First Addendum

Project Name Pier C Ridge Vent Rehabilitation

Project # 11204 Task 2 November 2023

November 28, 2023

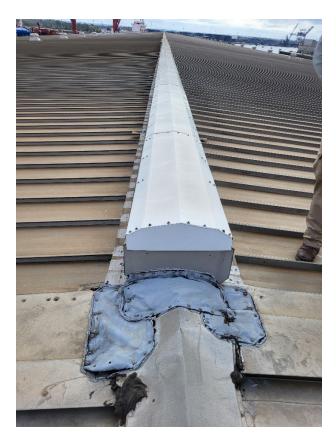
- 1. Contractor shall provide a scissor lift for personnel and materials access to and from the roof. The scissor lift shall be on-site for the duration of the project.
- 2. Contractor shall replace/reconstruct flashing and seals at four end condition of the coffin vent series. Typical end condition is shown here. Intent is to seal the ridge and ridge vent over the length of the awarded project.
